**TOWN OF NEWBURGH
 PLANNING BOARD
 TECHNICAL REVIEW COMMENTS**

PROJECT: ALDI EXPANSION
PROJECT NO.: 18-06
PROJECT LOCATION: SECTION 97, BLOCK 1, LOT 2
REVIEW DATE: 12 APRIL 2018
MEETING DATE: 19 APRIL 2018
PROJECT REPRESENTATIVE: APD ENGINEERING

SITE PLAN

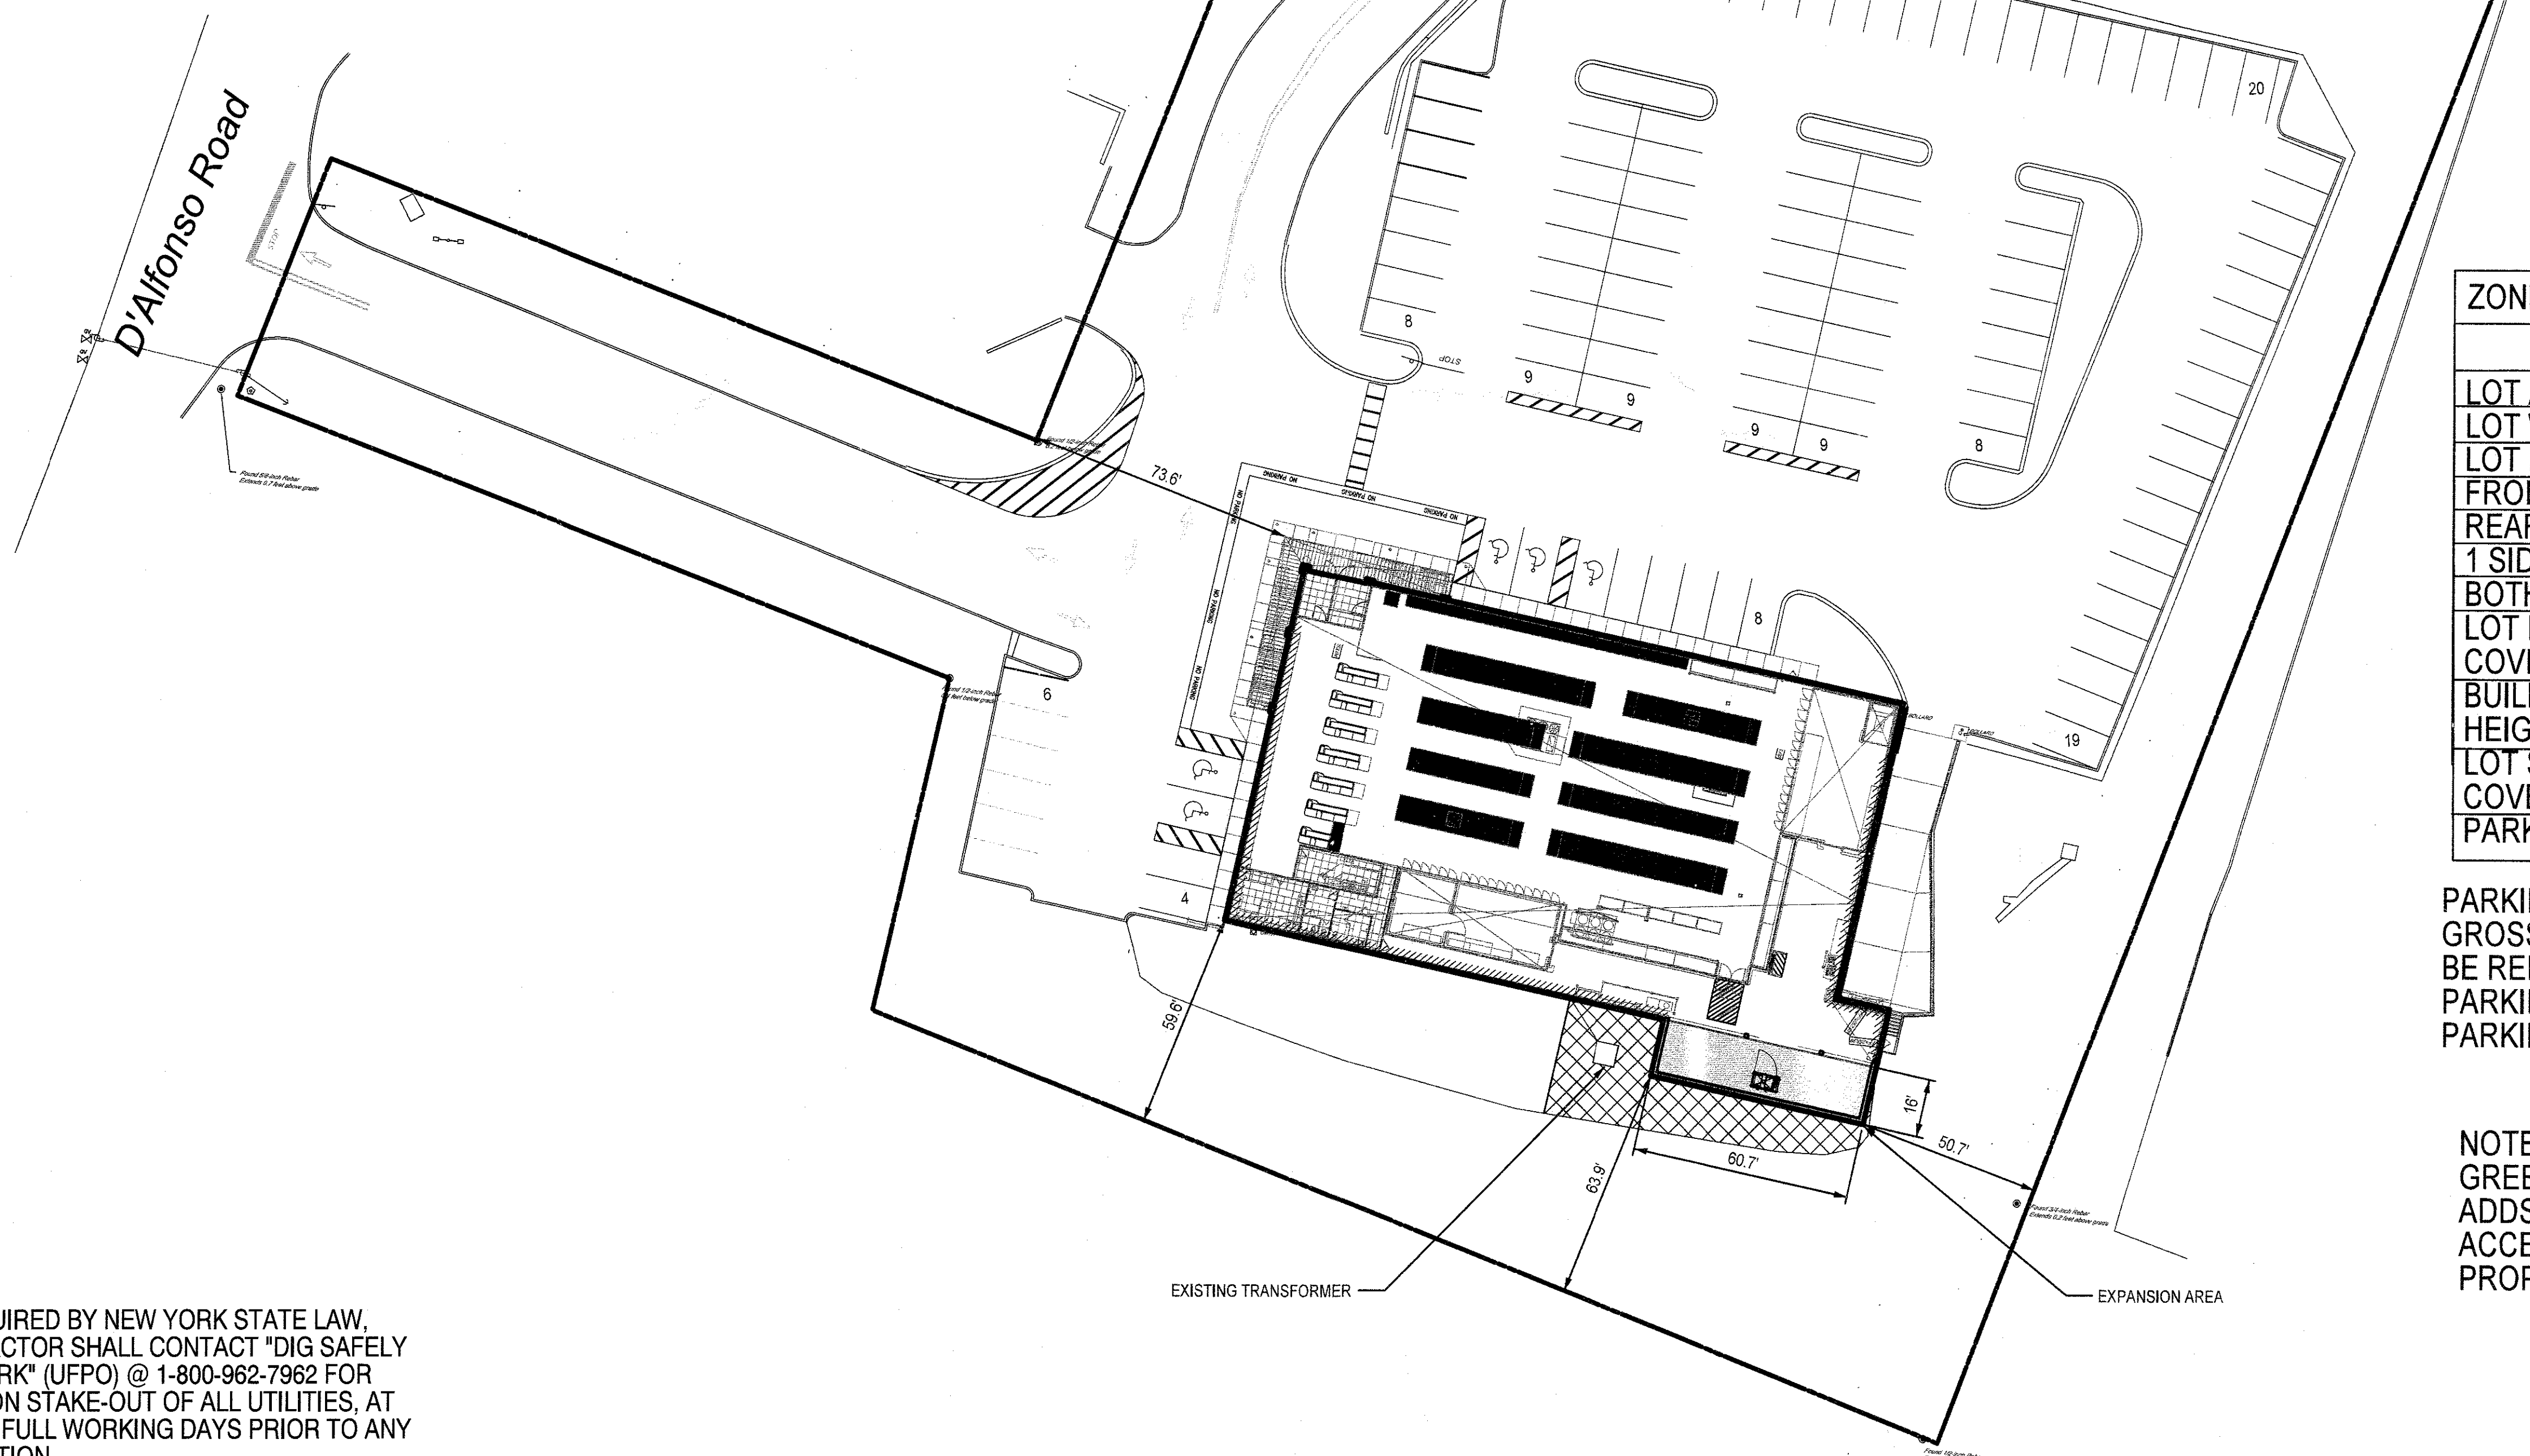
3. Details of the gravel removal, topsoil and seeding should be added to the plan sheet.
4. Project requires submittal to the Orange County Planning Department due to the proximity to NYS Route 17K.
